Access Compliance Report

Public Rights-of-Way

(Curb Ramps)

Intersection ID: 30210	Main Street: HIDDEN_CREEK_DR	Cross Street: N/A	Location: NE
ADA ID: D8699D1DB56A	Ramp Type: PerpDiag	Initial Pass/Fail: Fail	Overall Compliance: No
Severity Score: 8.75			
Codes/Mitigation Info/Possible Solution		Field Measurements/Component Compliance

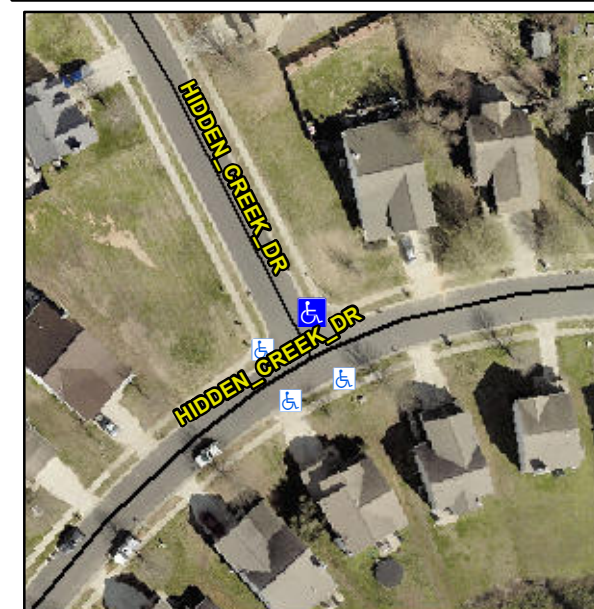
Not Found, R304.5.1

Compliance	Description	Data	Compliance	Description	Data
N/A	Ramp Length (in)	48.0	Yes	Ramp Slope (%)	5.0
No	Ramp Width (in)	45.0	Yes	Ramp XSlope (%)	1.0
N/A	Flare Type LT	N/A	N/A	Flare Type RT	N/A
N/A	Flare Slope LT (%)	N/A	N/A	Flare Slope RT (%)	N/A
N/A	Flare Traversable LT?	N/A	N/A	Flare Traversable RT?	N/A
N/A	Landing Length (in)	N/A	N/A	DWS Provided?	N/A
N/A	Landing Width (in)	N/A	N/A	DWS Contrast?	N/A
N/A	Landing Slope (%)	N/A	N/A	DWS Length (in)	N/A
N/A	Landing X Slope (%)	N/A	N/A	DWS Full Width?	N/A
N/A	Landing Curb? (Y/N)	N/A	N/A	DWS Offset (in)	N/A
N/A	Shared Landing?	N/A			
N/A	Gutter Ponding?	N/A	N/A	Gutter Slope (%)	N/A
N/A	Gutter Lip Ht (in)	N/A	N/A	Gutter X Slope (%)	N/A
N/A	Painted X Walk1?	No	N/A	Painted X Walk2?	No
	X Walk 1 Direction	To W		X Walk 2 Direction	To S
N/A	X Walk 1 Width (in)	N/A	N/A	X Walk 2 Width (in)	N/A
	X Walk 1 Slope (%)	0.3		X Walk 2 Slope (%)	0.9
	X Walk 1 X Slope (%)	1.5		X Walk 2 X Slope (%)	2.7

N/A	Ramp inside XWalk1?	N/A	N/A	Ramp inside XWalk2?	N/A
	Road Slope (%)	1.4	N/A	Clear Space?	N/A
	Road X Slope (%)	0.5	N/A	Clear Space to XWalk (in)	N/A
N/A	Any Obstructions?	N/A	N/A	Storm Grate/Utility Hazard?	N/A
	Obstruction Type			Storm Grate/Utility Type	
		N/A			N/A
		Yes		Surface Condition? (G/P)	Good

Remove & Replace Curb Ramp With Two New Directional Ramps or Equivalent.
